**Proposed clay excavation,
Lot 6 Almeria Parade, Upper Swan**

Midland Brick Company Pty Ltd

**Report and recommendations
of the Environmental Protection Authority**

**Environmental Protection Authority
Perth, Western Australia
Bulletin 608
January, 1992**

BORE (A)

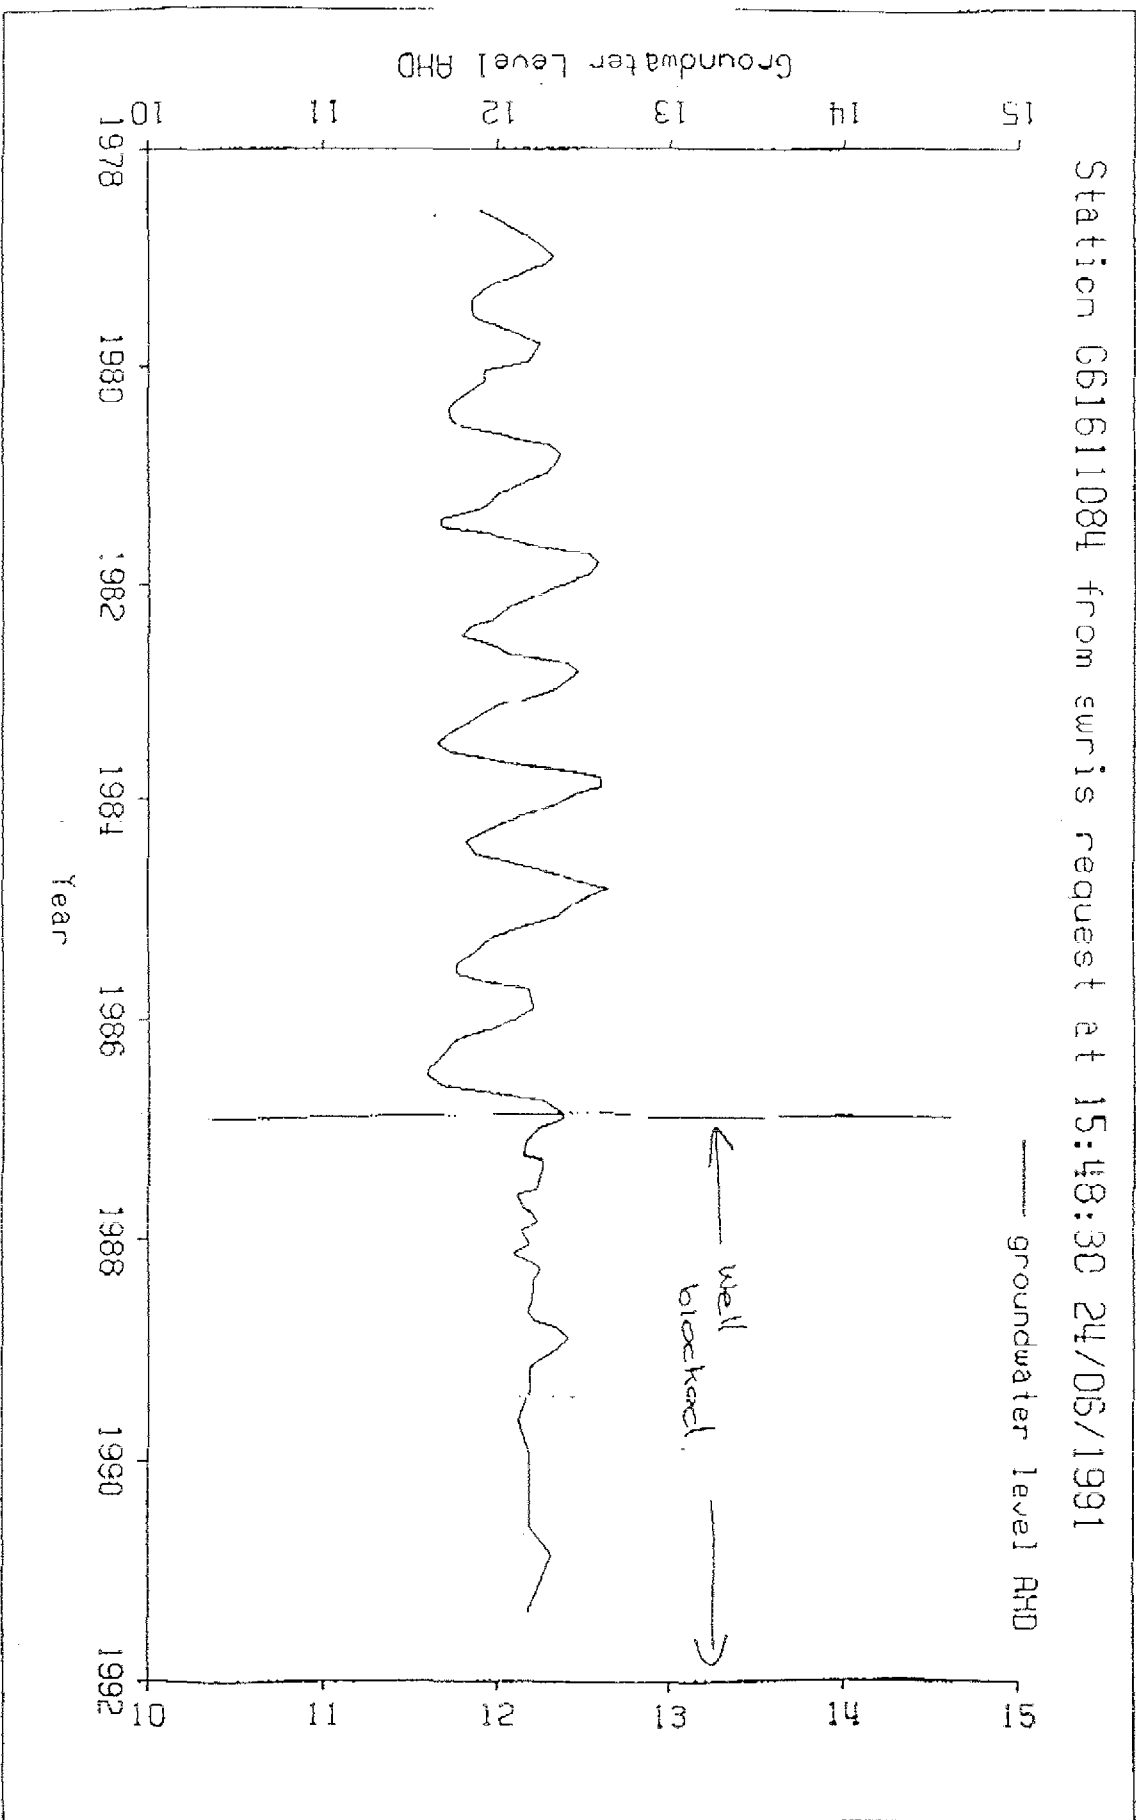
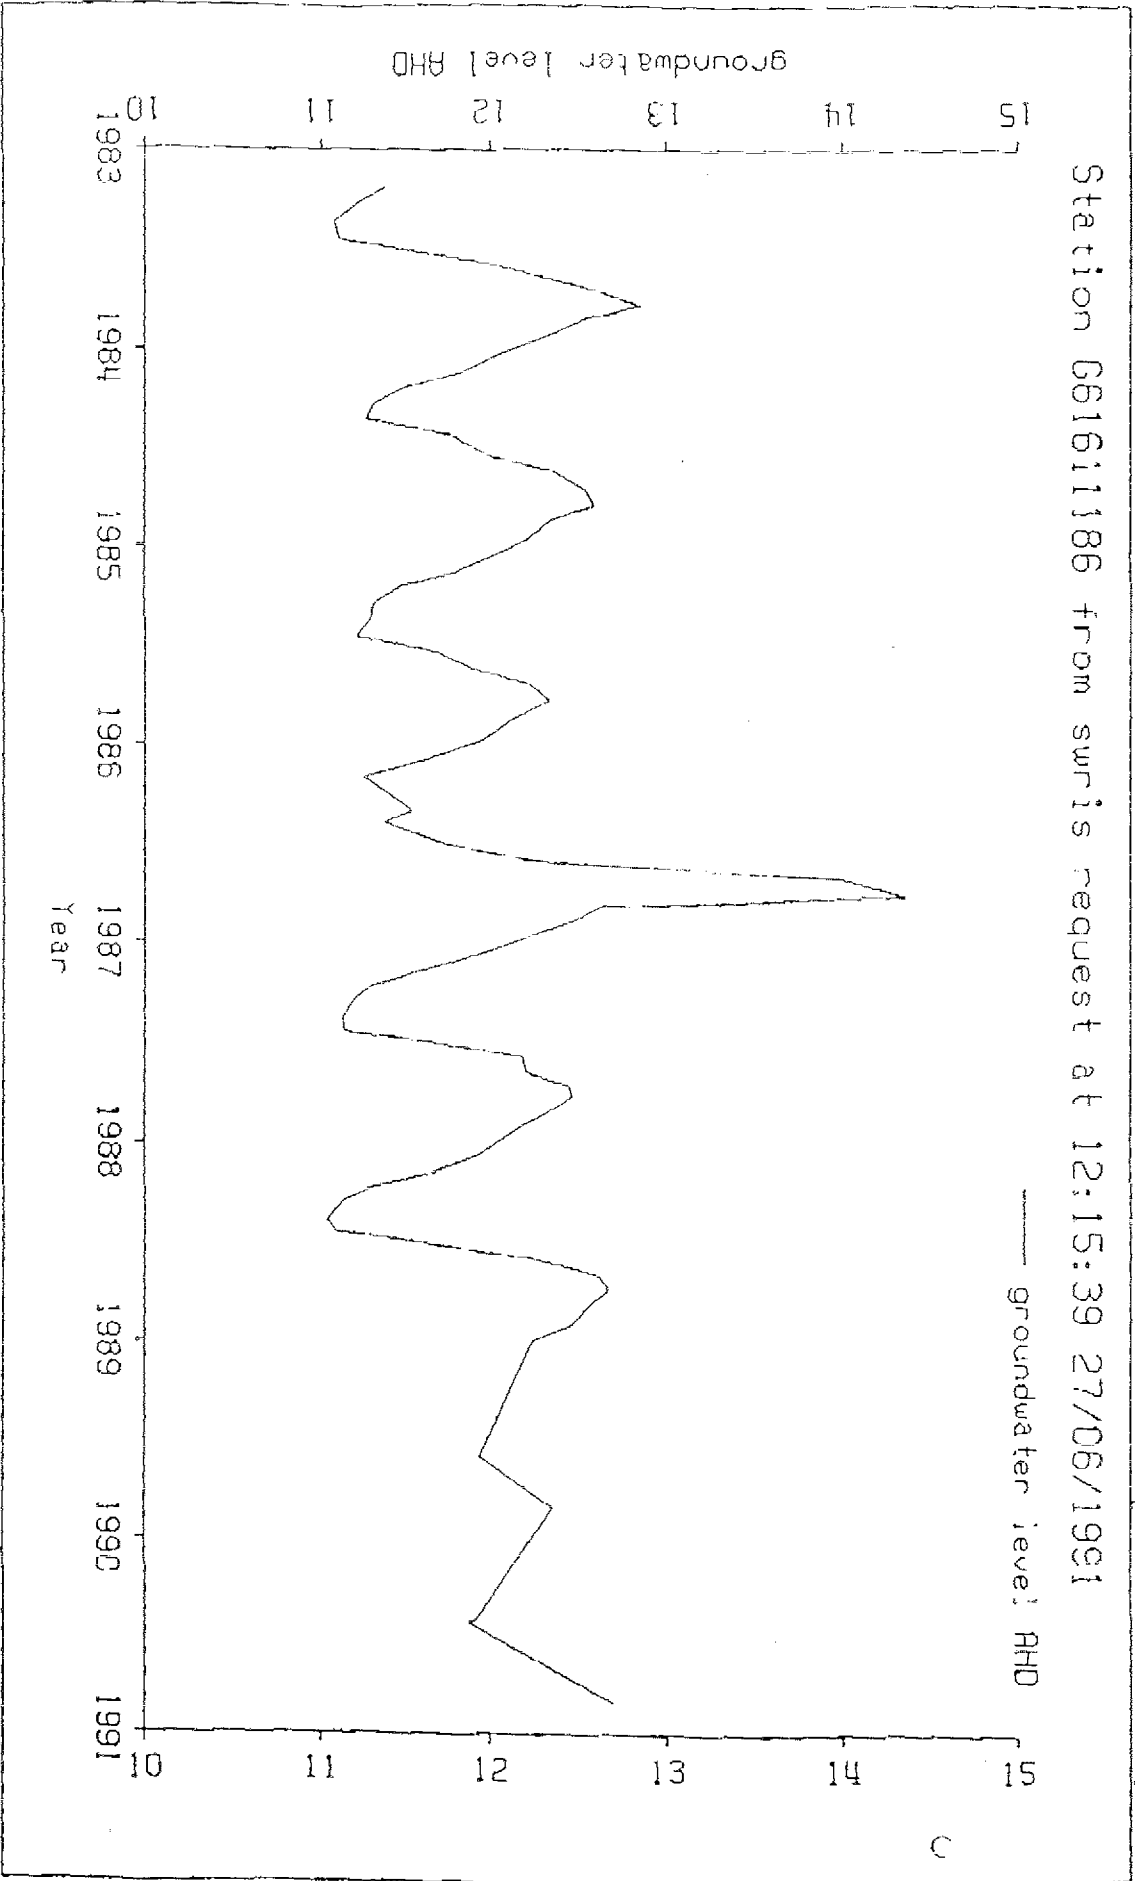
Q15. What data has been used to show the presence and depths of perched water tables and groundwater table levels?-P26. Does the perched groundwater sit on the plastic clay zone to be mined? If it does, won't the mining of clay

The only long term records available are from two Water Authority monitor bores near to Ellen Brook, in the vicinity of Lexia Avenue. (See Figure 2 for approximate locations). Up-dated hydrographs have recently been obtained from the Water Authority (Figures 3 and 4).

Figure 3 (Bore A) shows that the permanent water table is at about 12 metres AHD in the vicinity of Lexia Avenue and has fluctuated within a 1.0 metre range during the eight year period 1979 to 1987. Seasonal fluctuations as little as 0.4m have been recorded. Well EE9 (Figure 4) exhibits larger fluctuations in water level which probably reflects its proximity to Ellen Brook and interaction with winter flood levels in the watercourse.

LOCATION OF MONITOR BORES

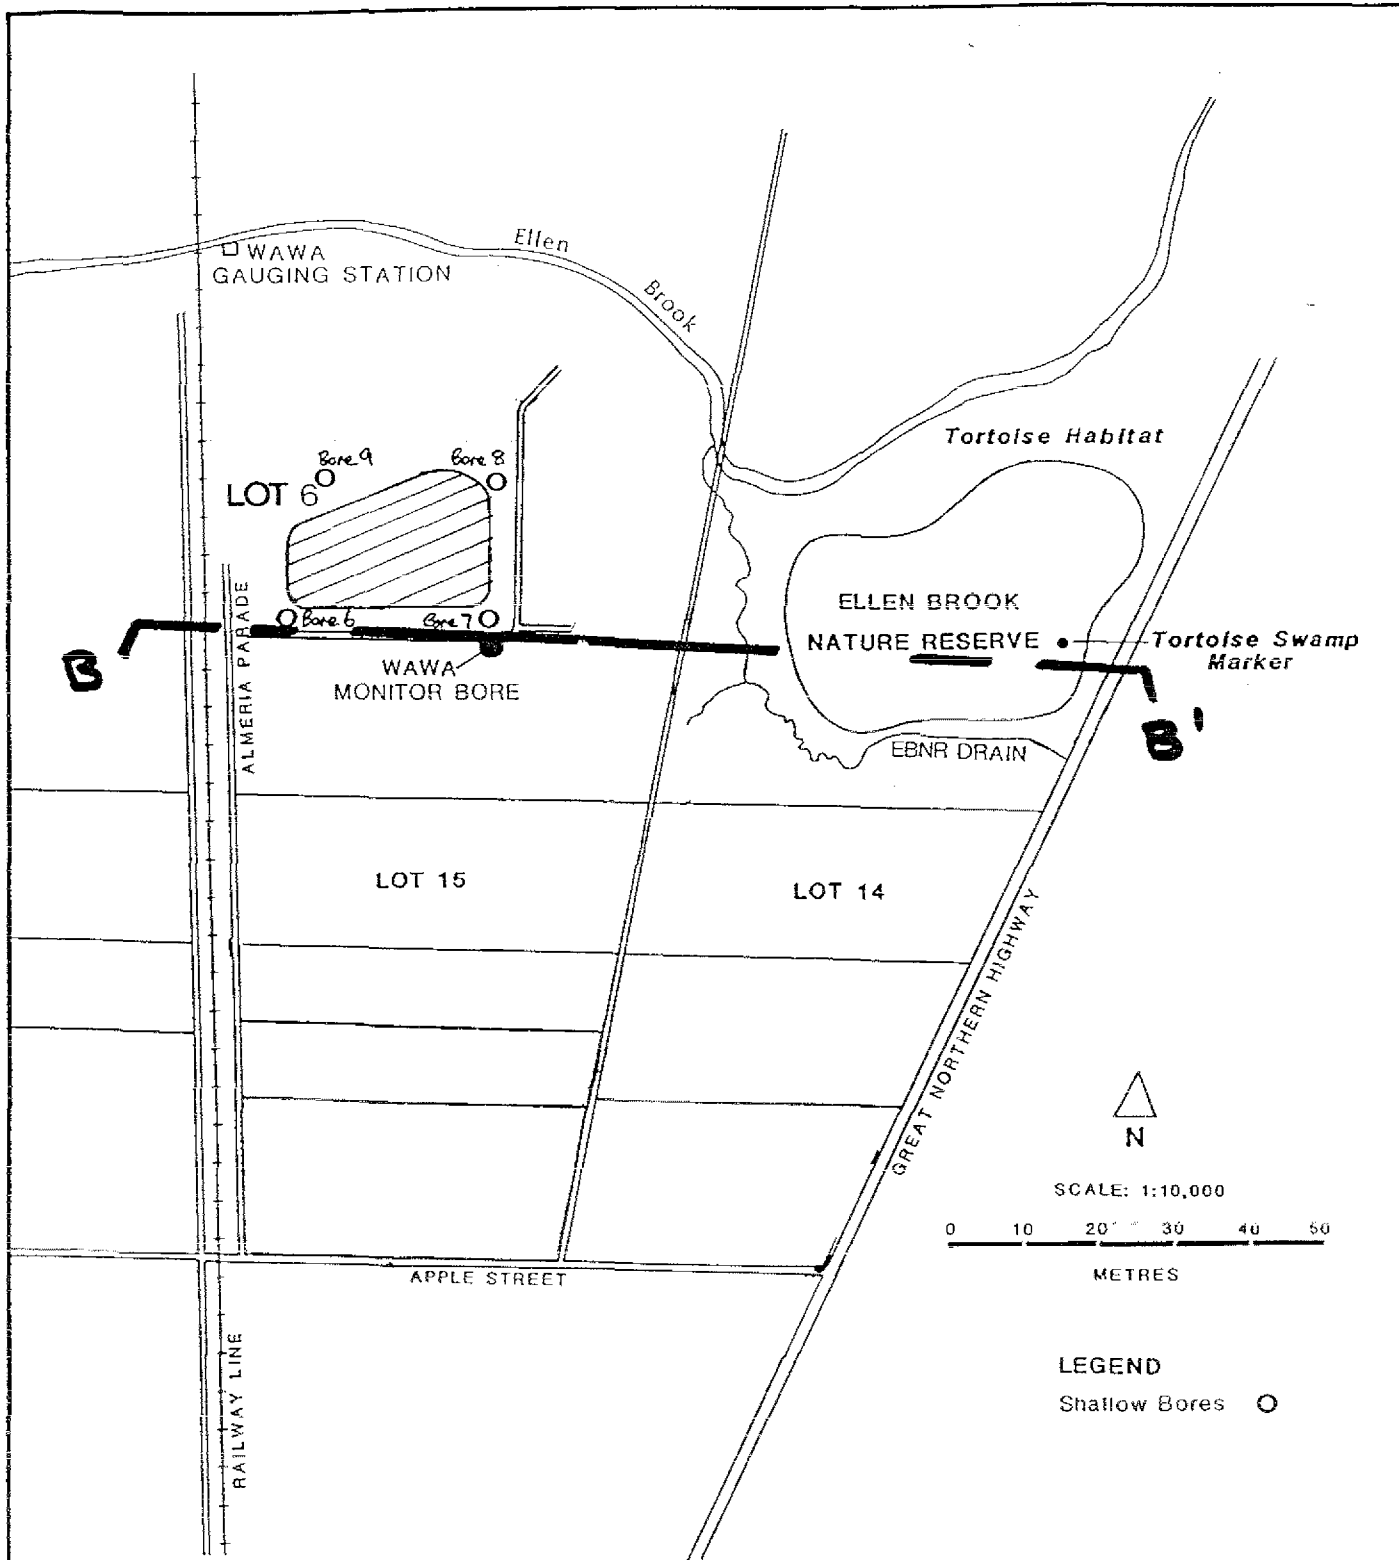
Q19. Detail on the presence and lateral continuity of the perched water table seems critical in achieving an understanding of the hydrology of the tortoise habitat area. Is there more data than that presented in Figure 11 that could assist EPA in evaluating these proposals?

The locations of monitor bores installed by Midland Brick are shown on Figure 5, along with dates of installation and the initial monitoring period. Only shallow bores were installed at Lot 6 Almeria Parade because excavation at this site will be restricted to a shallow depth and there is already a deep Water Authority bore at this site. The bore logs generally recorded strong 'grey' clay from the surface to about 3.5 metres, with the exception of Bore 9 which has 1.5 metres of coarse sand overlying the clay. Midland Brick's initial exploratory drilling encountered permeable coarse sands underlying this deposit.

Additional data from the groundwater investigations conducted by Midland Brick is provided under question 15 above and on Figures 5 and 6.

SCHEMATIC CROSS-SECTION SHOWING
RELATIVE WATER LEVELS

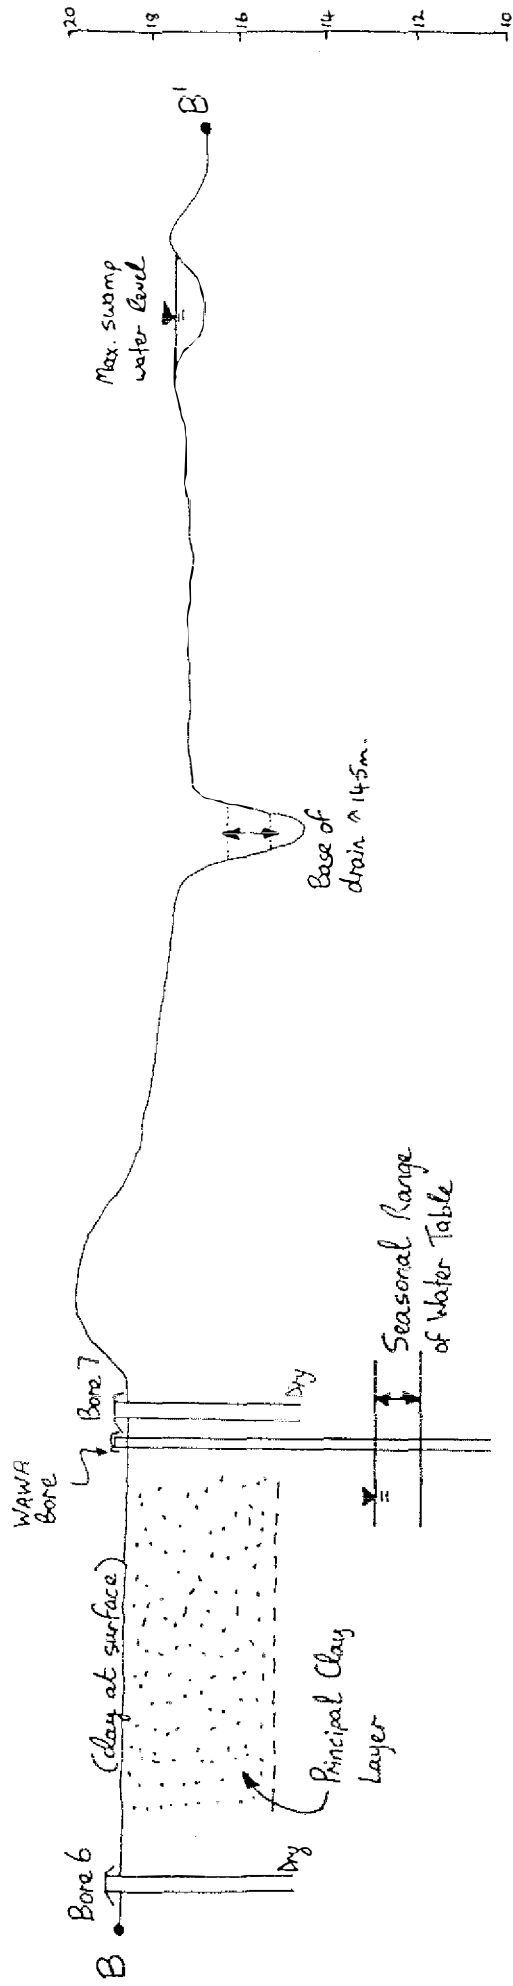
Q17. To assist EPA's assessment of likely impacts on the short necked tortoises' habitats, could the proponents provide a cross-section showing the perched and permanent water table levels relative to the water levels in the swamp, reserve, creeks and drain.-P.28.

A schematic cross-section is provided in Figure 6 (see Figure 5 for the approximate location).

The exploratory drilling and the monitor bore data clearly show that the clay layer to be mined is located more than two metres above the permanent water table (Figure 6).
